STAFF REPORT
(One-Step Final Plat)

CASE NUMBER: SUB 2006-105 -- THE FAMILY VIDEO ADDITION

SUB 2006-105 -- One-Step Final Plat of FAMILY VIDEO ADDITION

VICINITY MAP

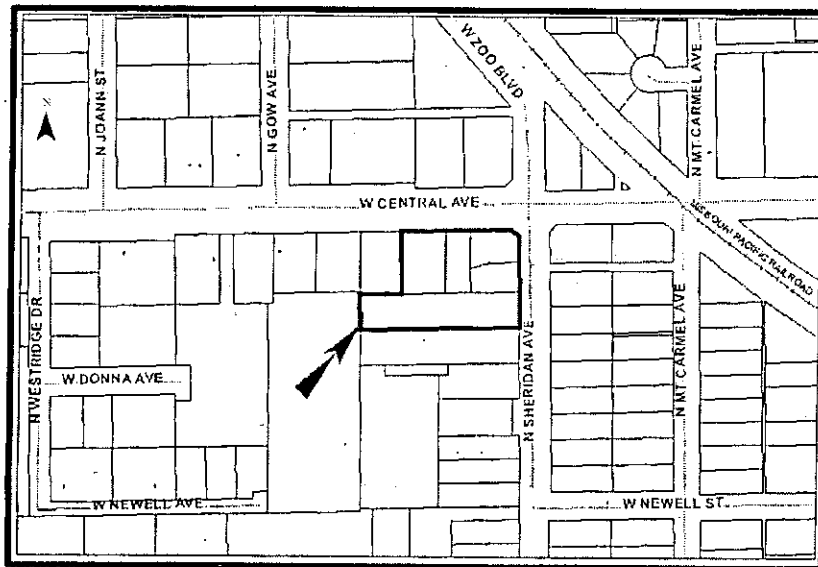
- C. City Engineering needs to comment on the status of the applicant's drainage plan.
- D. The word "Proposed" should be deleted from the sanitary sewer easement.

- E. Access controls need to be platted along Central in accordance with the site plan.
- F. The applicant shall guarantee the closure of any driveway openings located in areas of complete access control or that exceed the number of allowed openings. A Driveway Closure Certificate in lieu of a guarantee may be provided.

- G. Traffic Engineering needs to comment on the need for additional right-of-way along Central and Sheridan.
- H. A restrictive covenant shall be submitted that permits future cross-lot access with the abutting property owner to the west effective upon commercial development of that property.

- I. The Applicant has platted a 10-foot building setback along Sheridan which represents an adjustment of the Zoning Code standard of a 20-foot setback for the LC, Limited Commercial District. The Subdivision Regulations permit the setback provisions to be modified by the plat upon the approval of the Planning Commission.

- J. The site plan denotes parking spaces along Central encroaching into the 20-foot building setback. The Subdivision Regulations permit the setback provisions to be modified by the plat upon the approval of the Planning Commission. The platted setback should be reduced accordingly.

- K. In the title block "City of Wichita" needs to be added.
- L. The Applicant is reminded that a platting binder is required with the final plat. Approval of this plat will be subject to submittal of this binder and any relevant conditions found by such a review.
